Proposal Request

Project: Black & Williams Community Center - Gymnasium Improvements

PR #4: Mechanical Pad and Fence Enclosure Dimensions

PR #7: ALUMINUM STOREFRONT BULKHEAD & JAMB EXTENTIONS

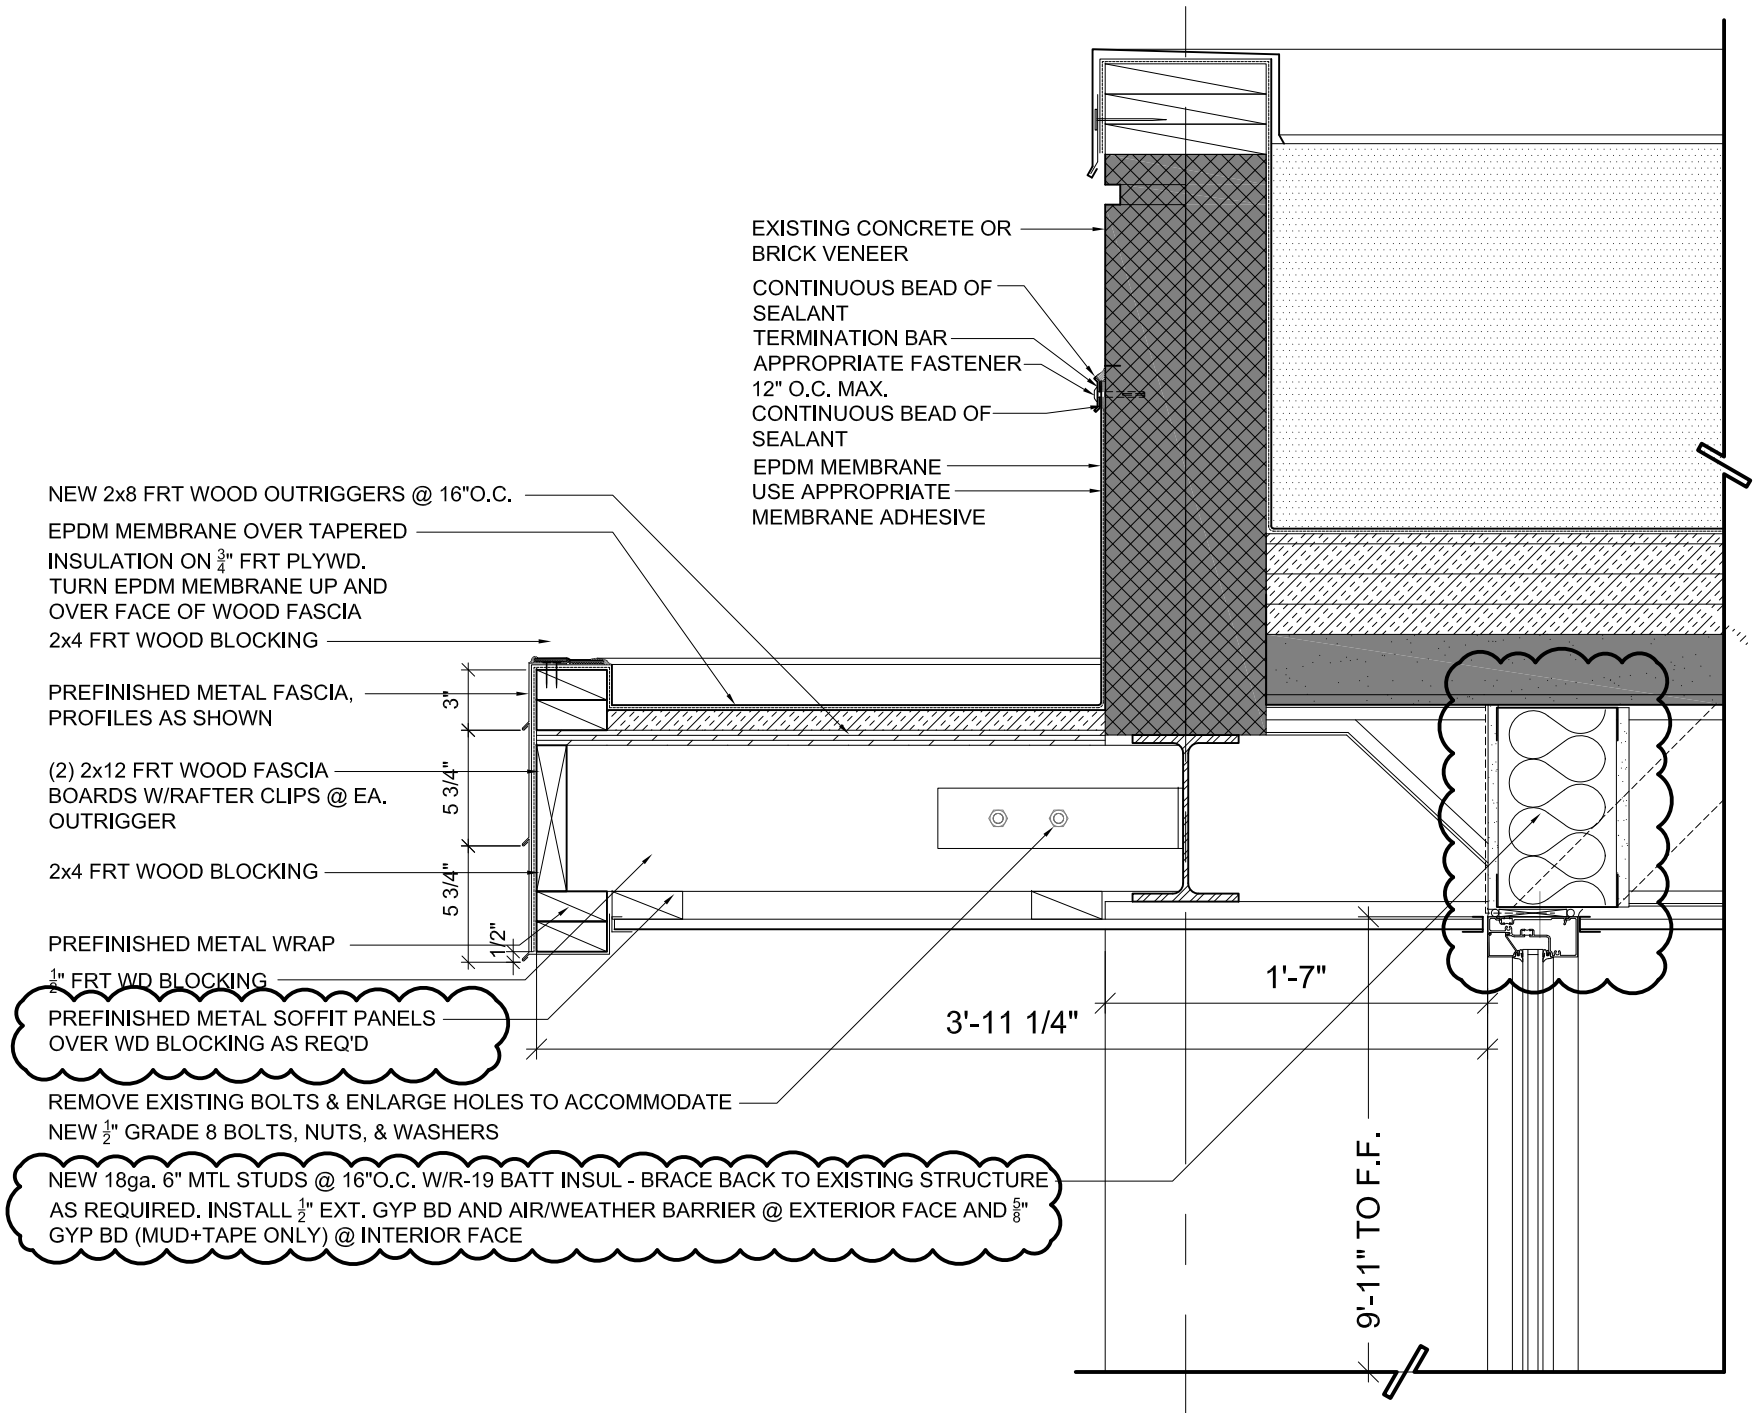
Per the found condition at the entry storefront location new metal stud bulkhead framing, sheathing, and insulation will be required in order to provide an attachment point for the storefront framing. See attached updated detail G/A1.3.
